**Addendum No. 1**

**August 28, 2025**

**City Project No.: 23-069**  
**Roads Program Capital Improvement Project**

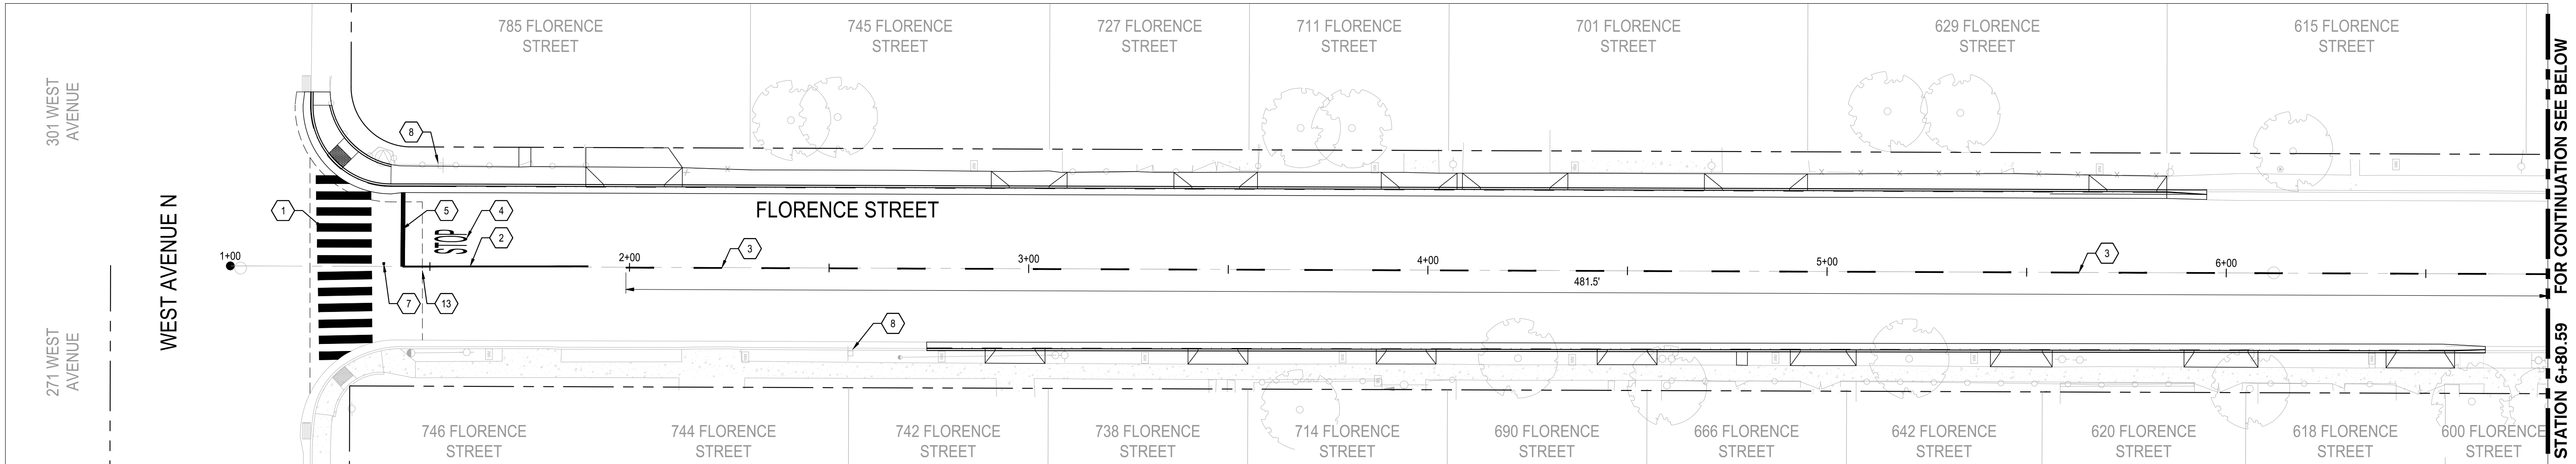
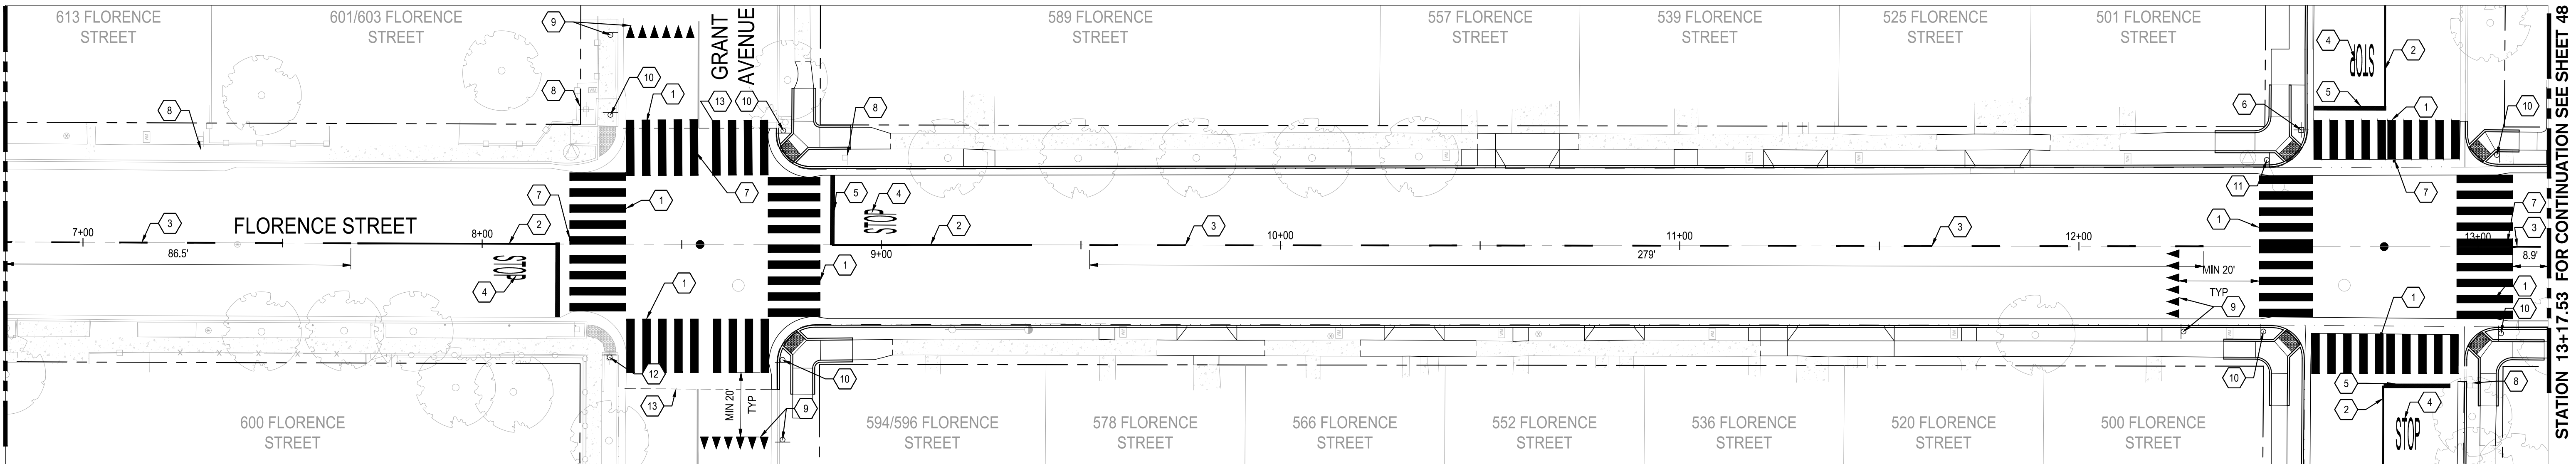
Sheet 45, Keynote #22: ~~RECONNECT UNDERDRAIN PIPE.~~  
**REINSTALL SIDEWALK UNDERDRAIN PER CITY OF TURLOCK STD. SD-7.**

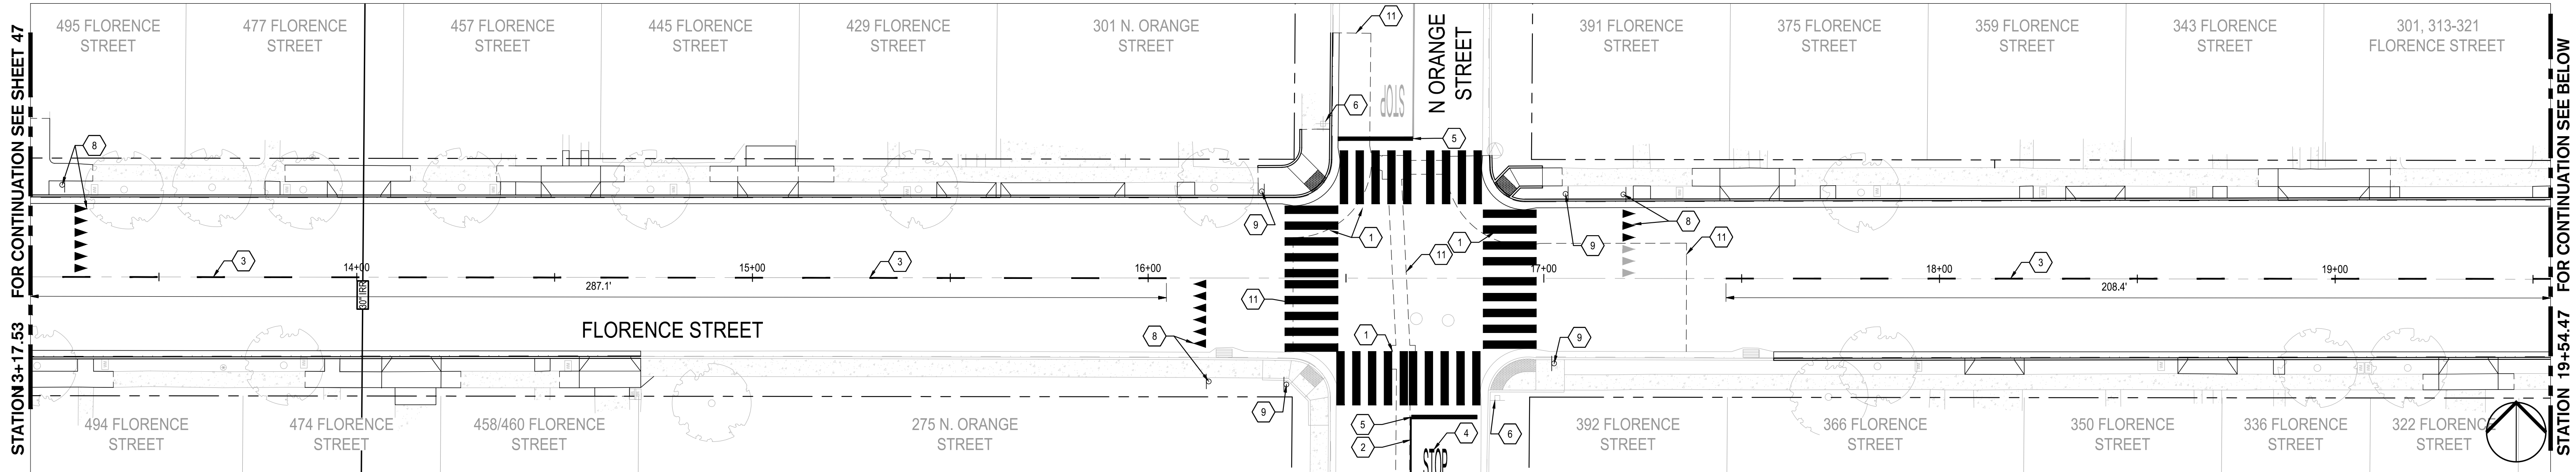
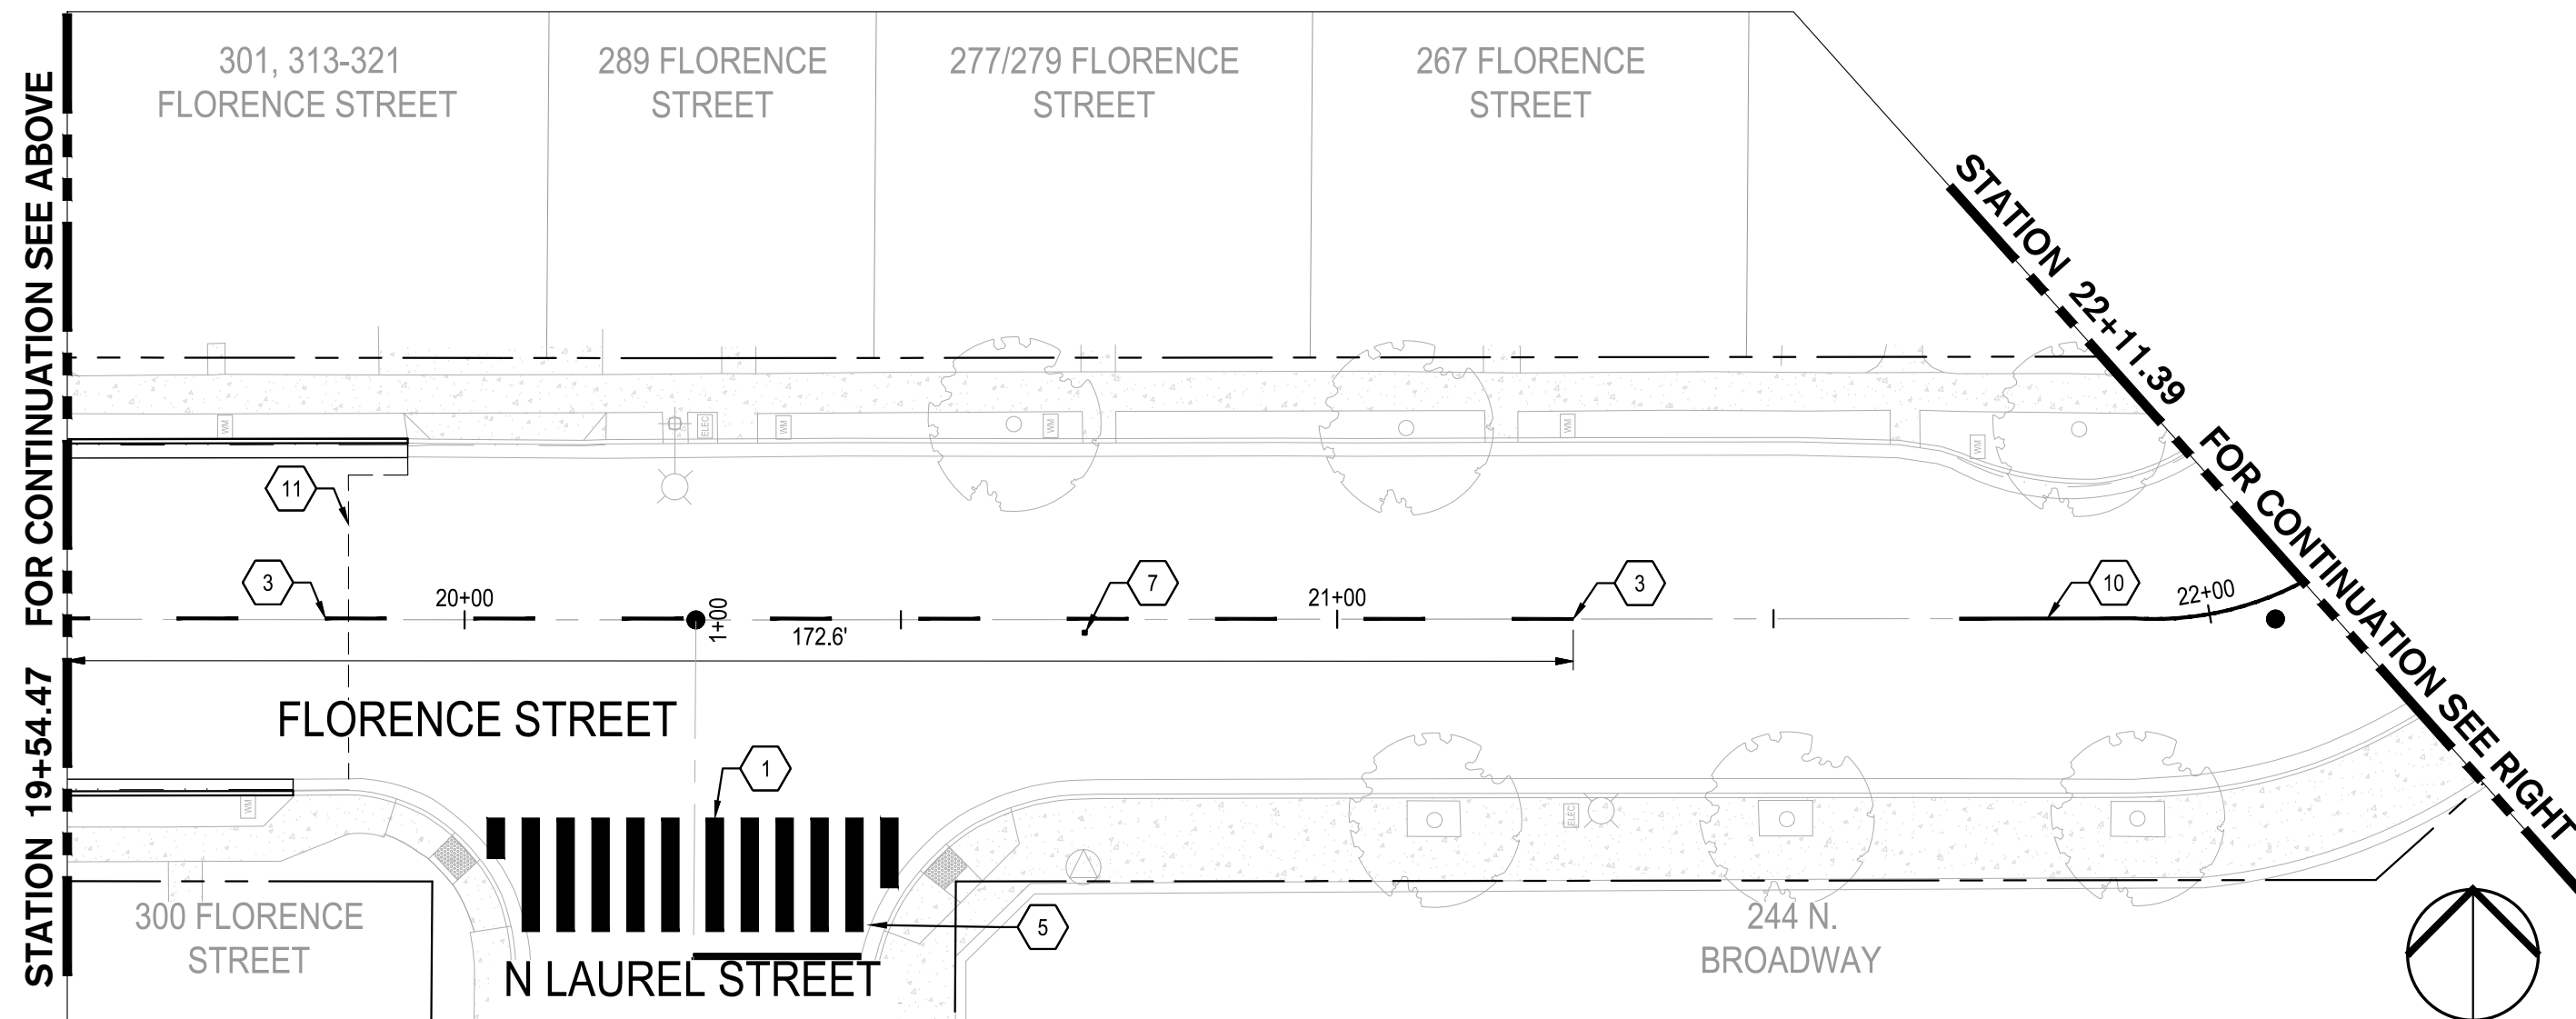
Sheet 47, Signing and Striping Notes, **ALL STRIPING REMOVED DURING THE STORM DRAIN INSTALLATION OUTSIDE OF THE ROADWAY RECONSTRUCTION AREAS SHALL BE REPLACED IN KIND** has been added to notes.

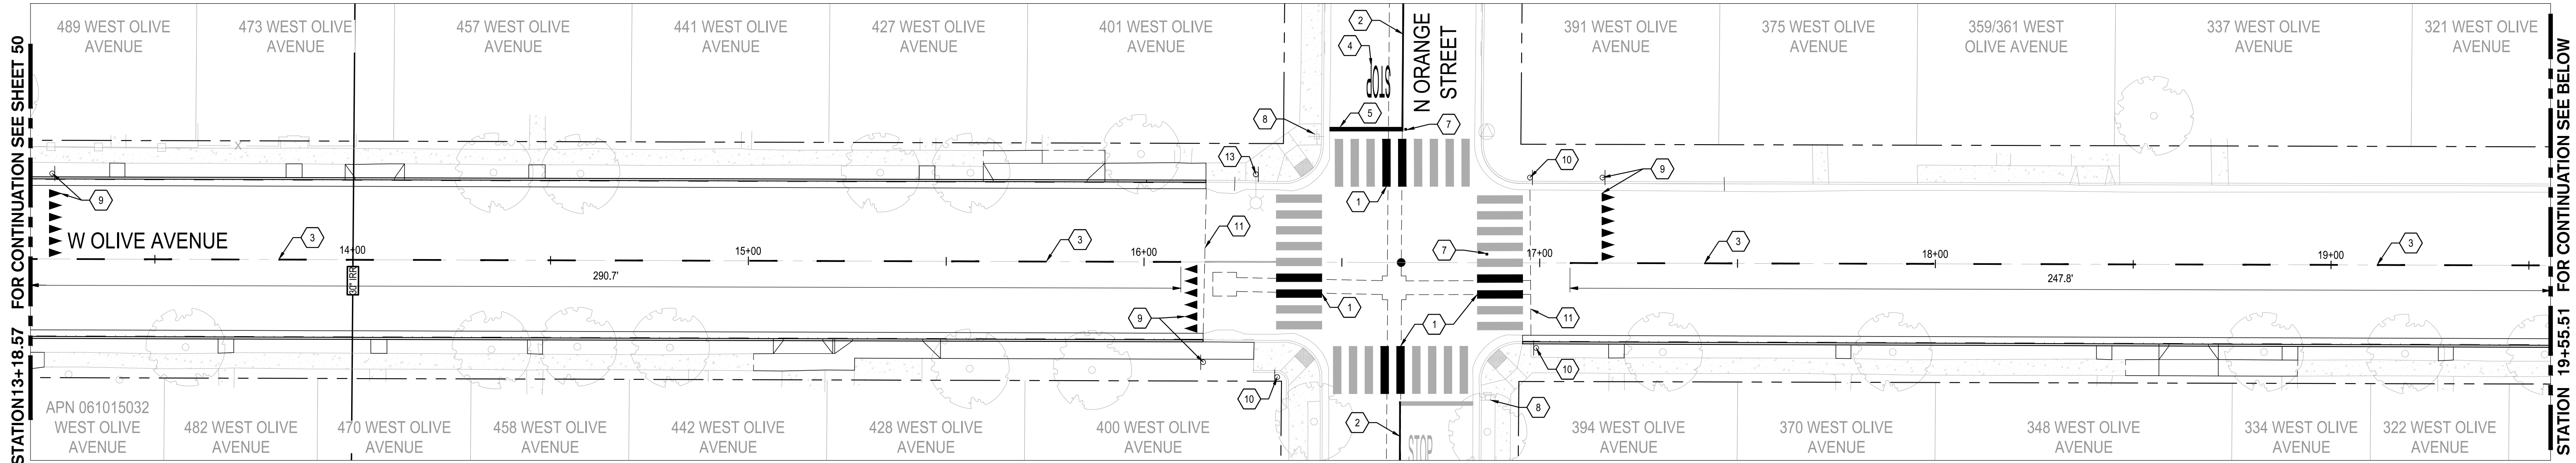
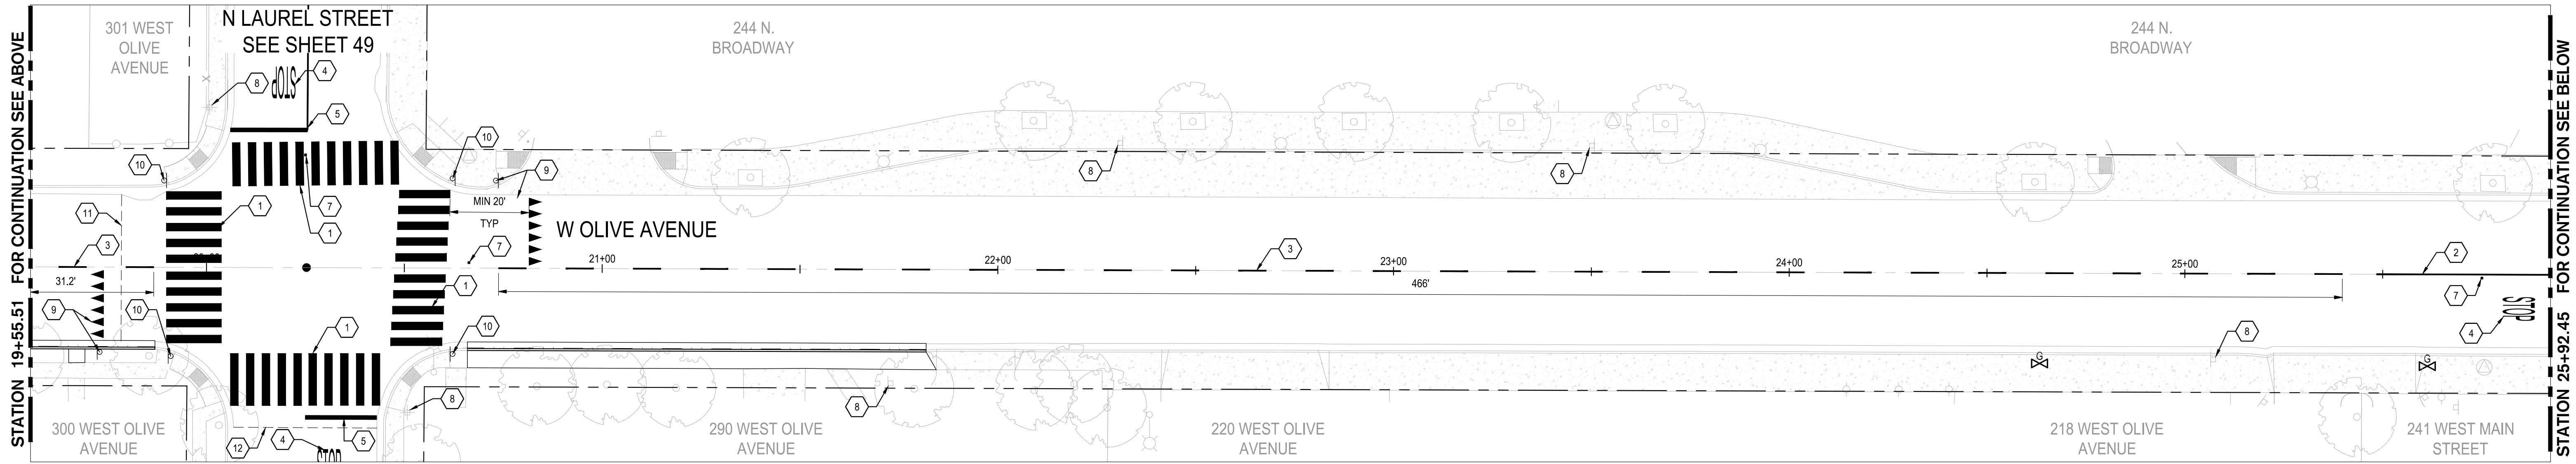
Sheet 48, Keynote 2 was added to Stripe 50' of Detail 22 on N Orange Street.
